**MEMORANDUM – Local Map Amendment**

**SUBJECT:** **Local Map Amendment No. G-836:** *(Deferred by the Planning Board at the April 27, 2006 Meeting)* Request by the Hearing Examiner that the Planning Board re-review the request by J. Kirby Development, LLC and Vedanta Center of Greater Washington seeks reclassification of 16 acres of land from the RE-2 zone to the PD-2 zone for up to 21 single family detached residences (one existing), up to 12 single family attached residences and 6 townhouse units (MPDU) and expansion of an existing worship center. Located at intersection of Bel Pre and Homecrest Roads. Potomac – Aspen Hill Master Plan

**FILING DATE:** February 22, 2005  
**PLANNING BOARD:** October 20, 2005, April 27, 2006  
**PUBLIC HEARING:** August 6, 2006

CROSS SECTION THROUGH HOMECREST ROAD SHOWING ADJACENT PROPERTY RELATION TO THE SUBJECT PROPERTY

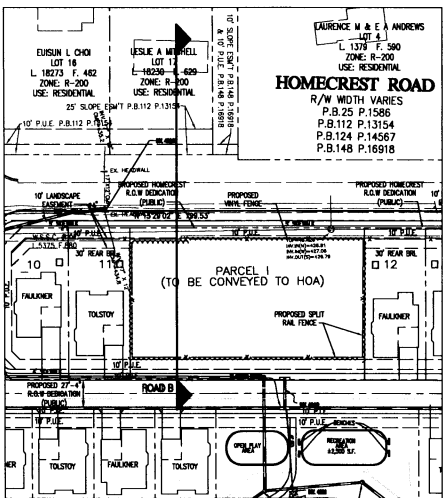
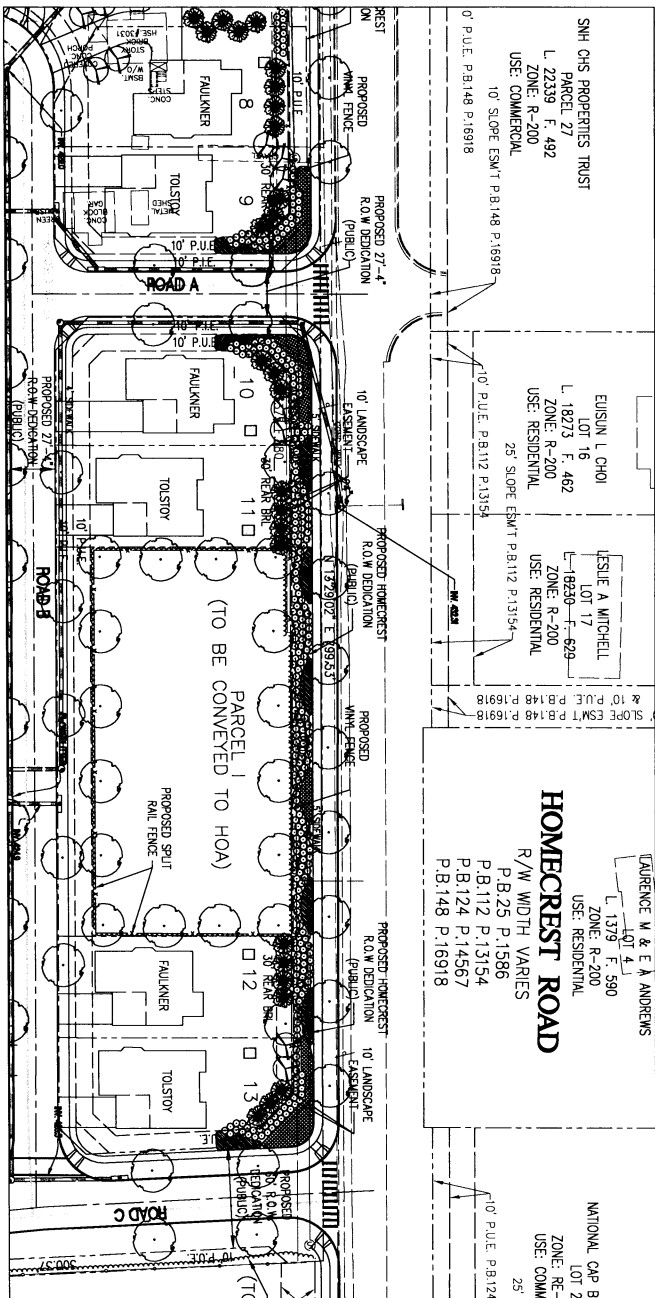
**The testimony indicated that Applicants intent to provide a small dedication of land along the site's Homecrest Road frontage, but this dedication is not clearly shown on the Development Plan. The intent is to provide 35 feet from the property line to the center of the roadway, consistent with a master plan recommendation that Homecrest Road should have a 70-foot-right-of-way.**

**3. Textual binding element No.4 states that fencing and landscaping "as shown on the Development Plan along Homecrest Road (within 10 feet of lot lines) shall be maintained by the Homeowners Association." This is consistent with testimony during the hearing, which indicated that the HOA would ensure uniform fencing and landscaping between the rear yards of the new homes and Homecrest Road. The Hearing Examiner, however, could not find any indications on the submitted Development Plan of fencing or landscaping along Homecrest Road. The graphic portion of the Development Plan and the textual binding elements must be consistent.**

**4. The Development Plan submitted here shows very clearly the intended road**

right-of way dedications for Roads A, B, and C, including the possible future extension of Road C along the full length of the northern boundary. It does not clearly show, however, the intended right-of-way dedication along Homecrest Road that was described during testimony. This omission must be rectified.

*The plan shows the required 35' from centerline dedication along the entire length of road frontage of Homecrest Road, which is consistent with the Master Plan recommendation.*

*The graphic portion of the Development Plan has been revised to show the Landscaping and uniform fencing within 10 feet of the rear lot lines adjacent to Homecrest Road to be consistent with Additional Textual Binding Element note number 4, and the testimony during the Hearing.*

*The plan has been corrected to show the required Right-of-Way dedication along Homecrest Road. The plan shows the required 35' from centerline dedication along the entire length of road frontage of Homecrest Road, which is consistent with the Master Plan recommendation.*
